GRAND ISLE AND VICINITY LOUISIANA

General Design Memorandum

United States Army
Corps of Engineers

beach erosion and hurricane protection

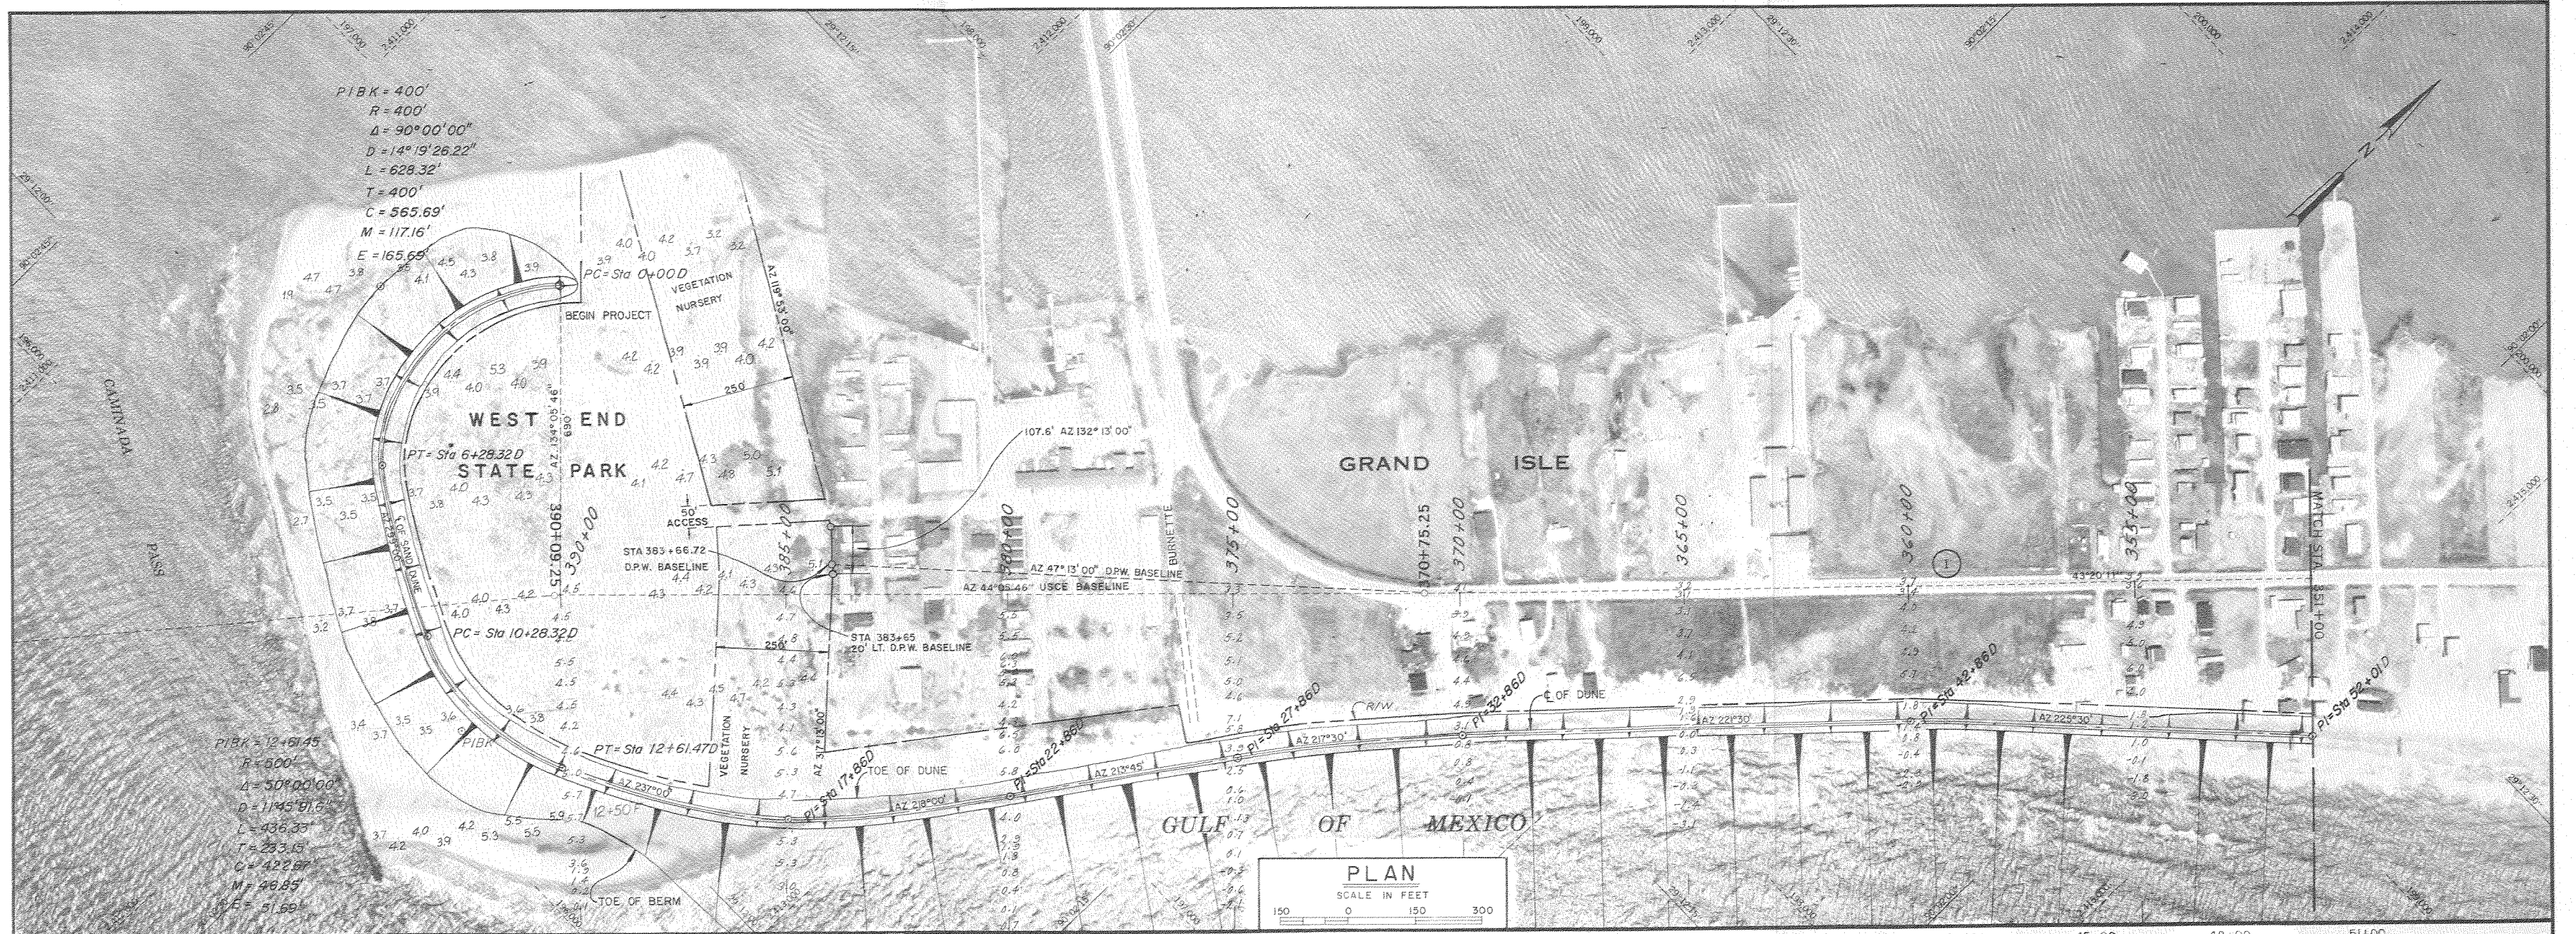
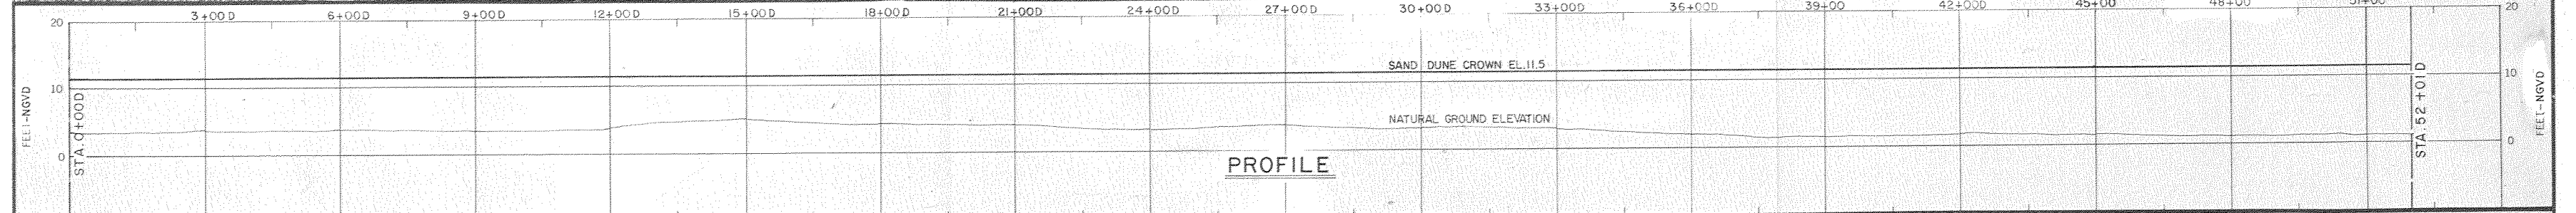
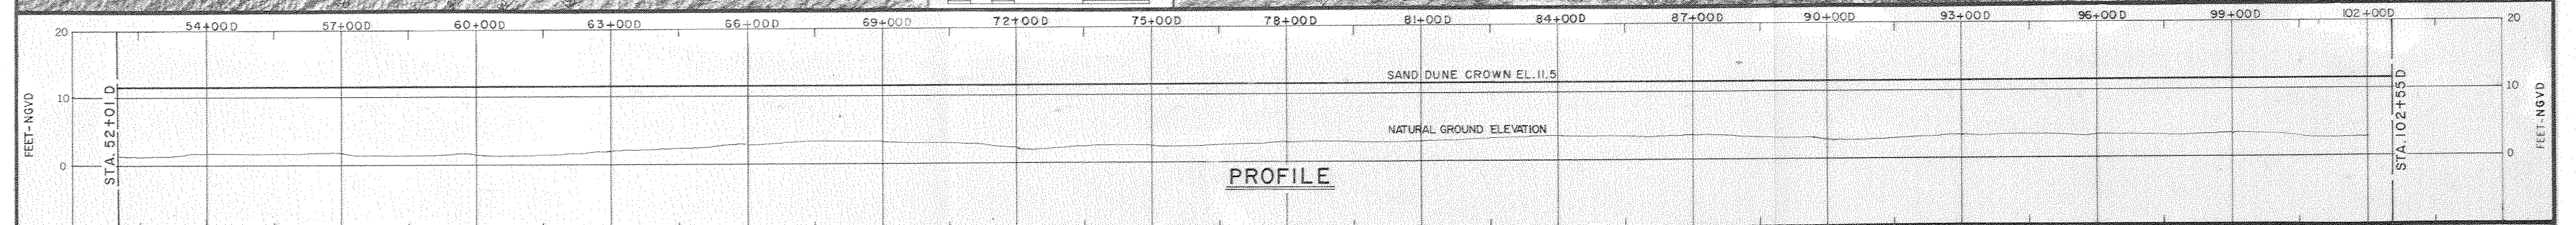
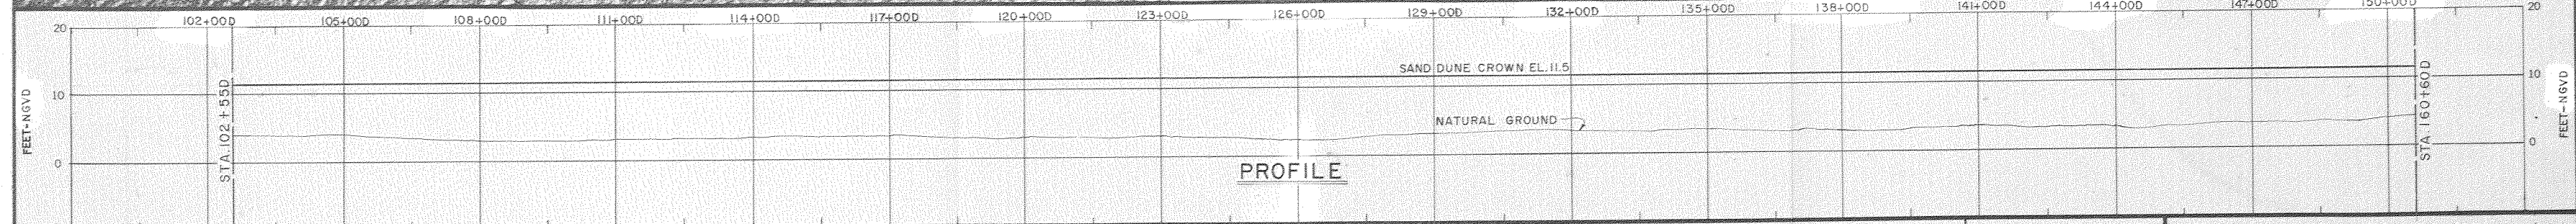
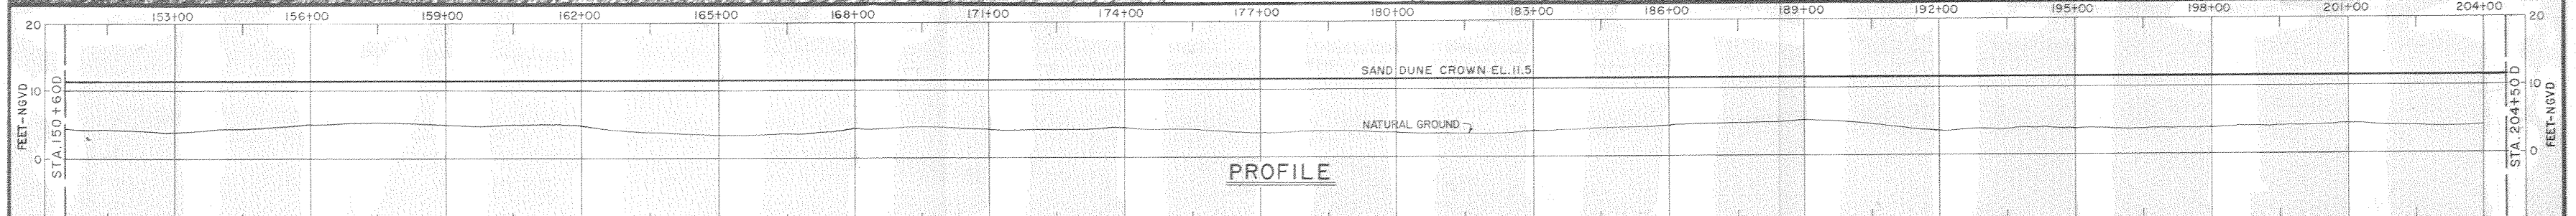
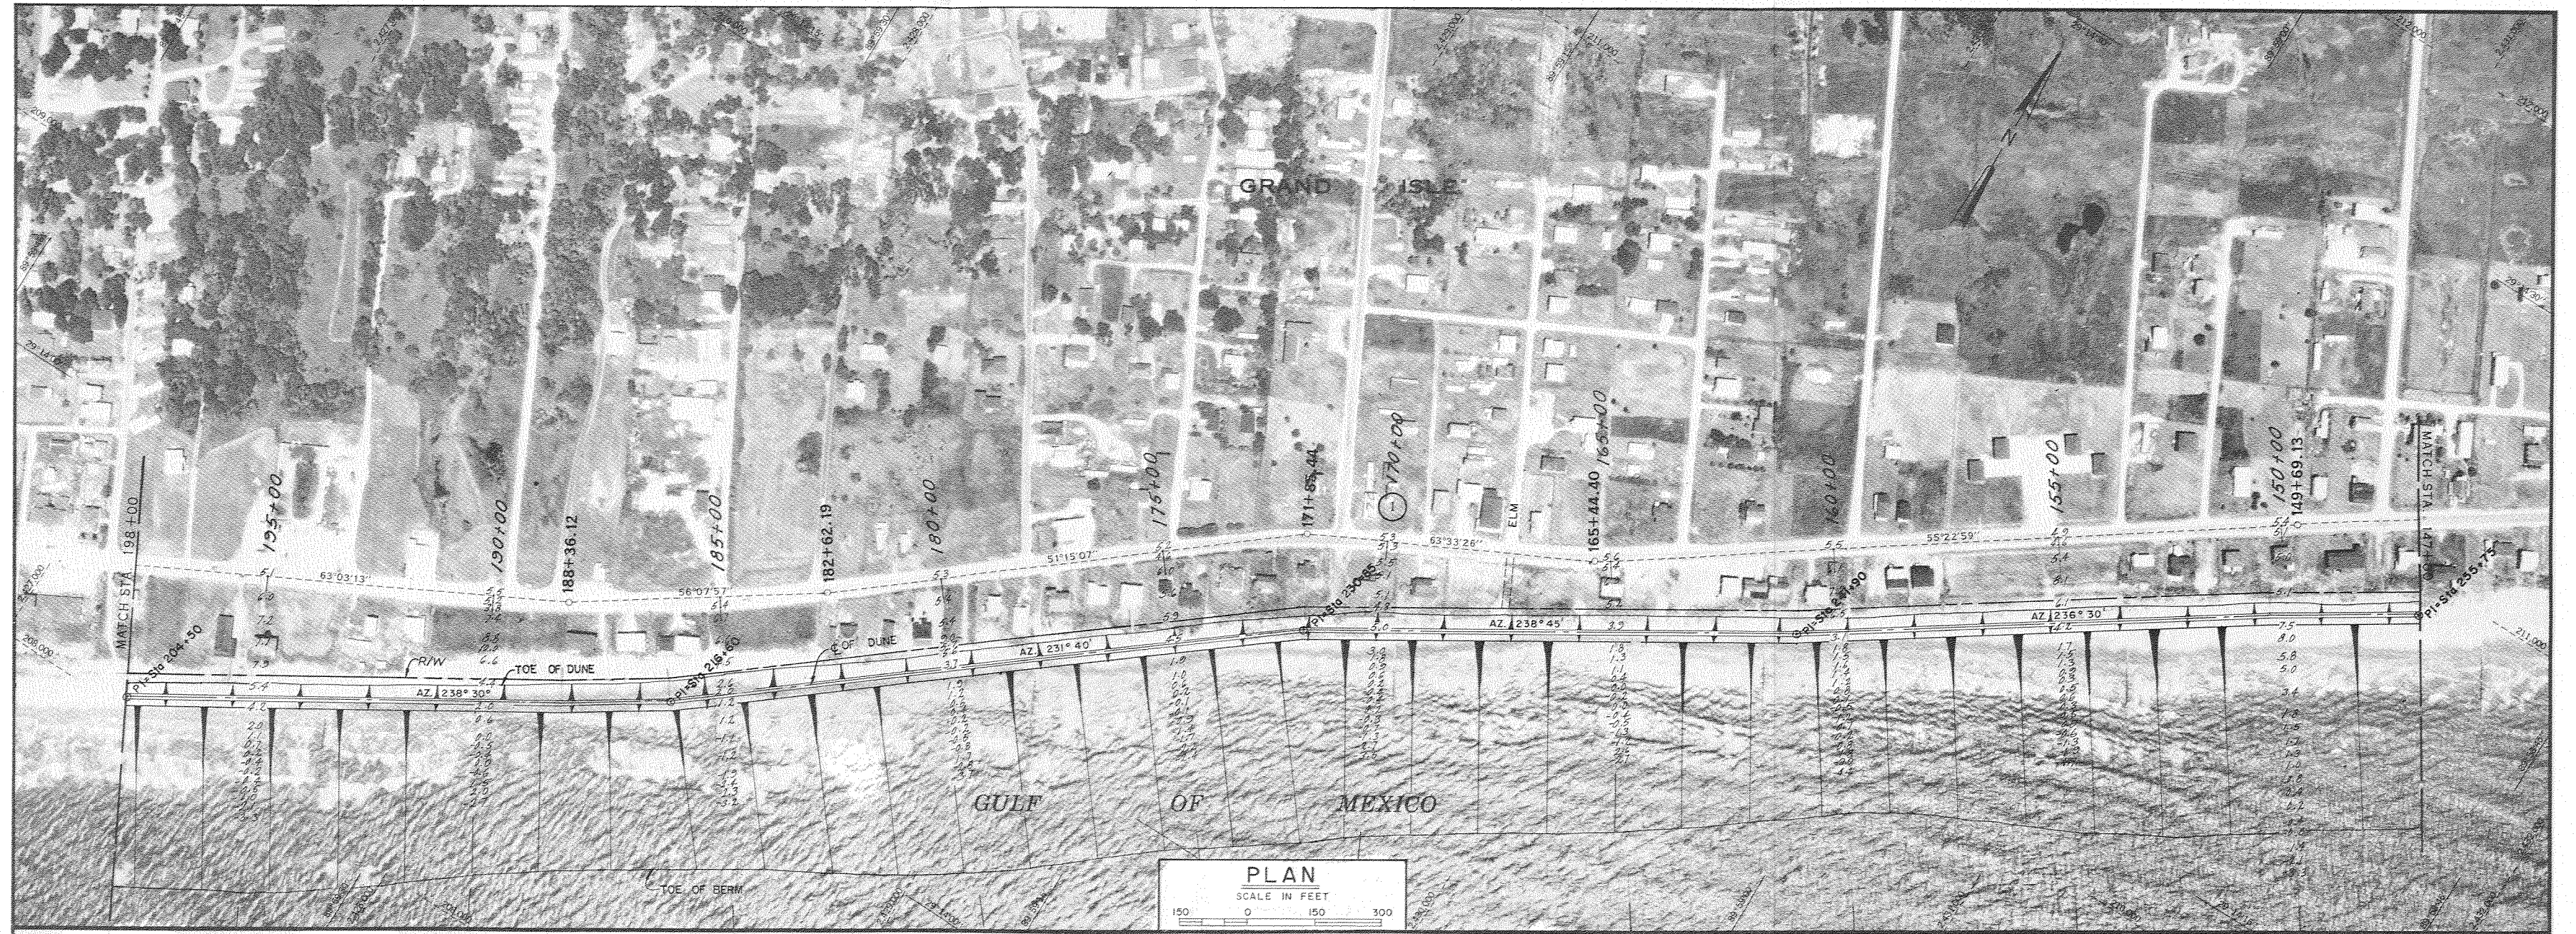
i. Plates 2 through 10. Apparently, surface drainage on the Gulf side of the highway is toward the Gulf. If this is the case, the proposed dune embankment may block this drainage. This could be particularly critical in areas where the natural ground is depressed between baseline Stas 192 and 180 and 126 to 115. This should be investigated and discussed in more detail.

b. Para 2i. It is not apparent why the location of significant low
spots adjacent to the proposed dune cannot be identified prior to the start
of construction of the sand dune. The plan and profile plates in the GDM
indicate that such low spots will exist between about baseline Stas 192 to
180 and 126 to 115. The need to fill such areas should be evaluated and
determined prior to submittal of plans and specifications so that such work
can be included in the plans and specifications and the project cost estimate.

i. Plates 2 through 10. Concur. At the present time, there is no city drainage system at Grand Isle, nor are there plans to construct one. Heavy rains have produced and will continue to cause temporary street flooding on the island. The runoff is more or less adequately disposed of mainly by percolation and seepage through the sand. The newly constructed dune will not hamper this process. Low spots adjacent to the proposed dune may exist at various locations near the beach and could collect and temporarily hold water. The exact location of these problem areas will not be known until construction of the sand dune has started. Modifications to the contract may be required to fill in these low areas.

b. Para 2.i. During the Plans and Specifications phase of design, significant low spots adjacent to the proposed dune will be identified and plans to fill these low areas will be shown on the construction plans.
